**REQUEST FOR INFORMATION (RFI)**  
**36C250-18-B-0081**

PROJECT NUMBER:	610-15-100	<b>Please ensure that before submitting questions or requests for clarification that you thoroughly read the solicitation, specifications, drawings and other pertinent documents. When submitting questions on this project the Government requires contractors to specifically identify the specification and/or solicitation section(s) or drawing number(s) in reference to the question or request for clarification submitted. No question or request for clarification will be answered by the Government unless the above requirements are met. Failure to comply may prevent the Government from responding in a timely manner.</b>
PROJECT TITLE:	Demolish Bldgs. 7,10,11,18,24,60 and Connecting Corridors	
PROJECT LOCATION:	Department of Veterans Affairs VA Northern Indiana HCS 1700 E. 38 <sup>th</sup> Street Marion, IN 46953

RFI NO.: #E10	DATE:	SPEC/DWG. REFERENCE(s):
		ET-103 – Coded Note #2
REPLY NEEDED BY: 1-2-2018

A SITE PLAN  
ELECTRICAL DEMOLITION / NEW WORK

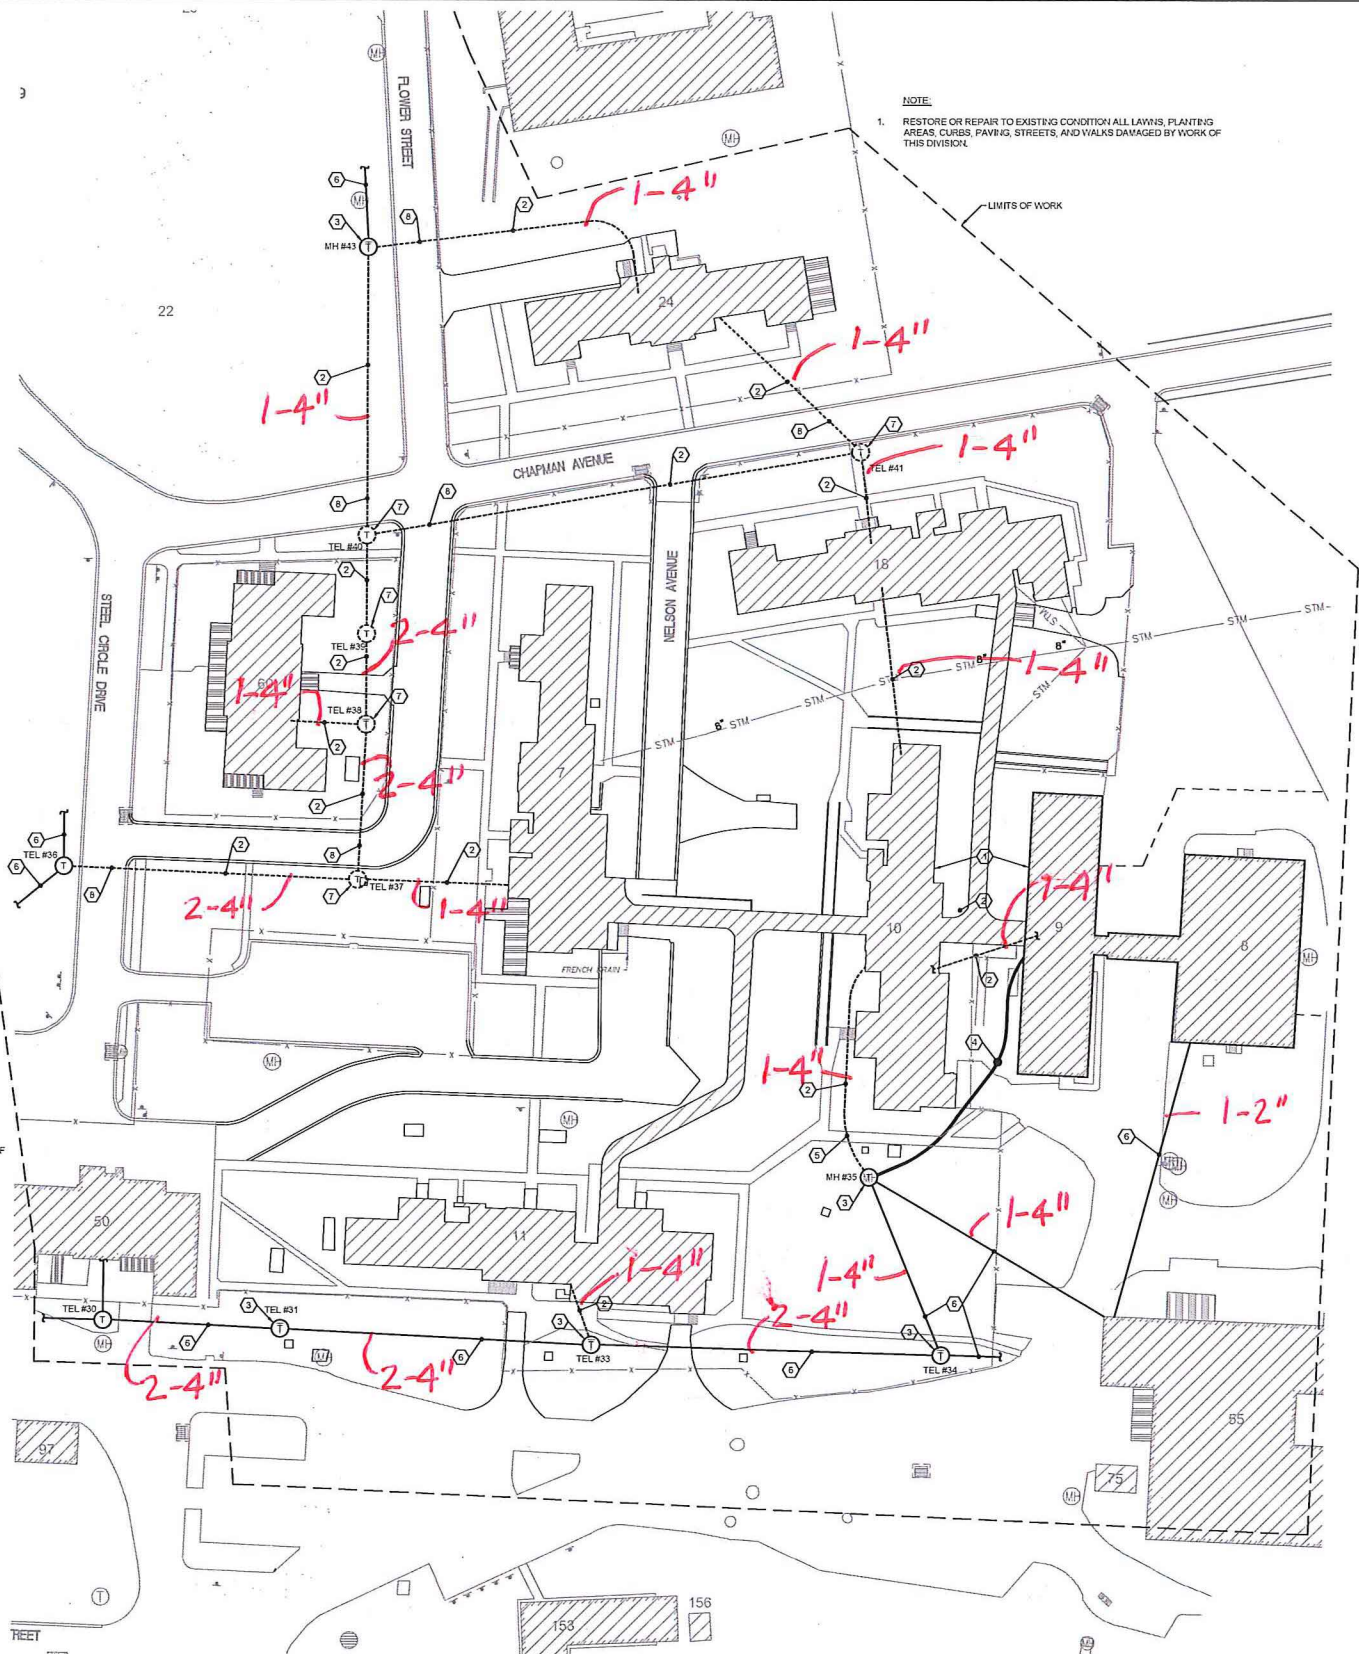
How many & what size conduits are used for the communication ductbanks?

- CODED NOTES
1. RELOCATE IT EQUIPMENT IN BASEMENT OF BUILDING 10 TO BUILDING 9
  2. REMOVE CONDUIT AND CABLEING.
  3. EXISTING MANHOLE TO REMAIN.
  4. PROVIDE 1-4" CONDUIT DUCTBANK INTO BUILDING.
  5. PULL BACK FO CABLEING TO MAN HOLE AND PULL THRU NEW DUCTBANK AND RE-TERMINATE IN BUILDING. TEST CABLE BEFORE REMOVAL, AND RE-TEST AFTER INSTALLATION. PULL OUT COPPER UTP CABLE.
  6. EXISTING DUCTBANK AND CABLEING TO REMAIN.
  7. REMOVE MANHOLE.
  8. ABANDON CONDUIT UNDER ROAD.
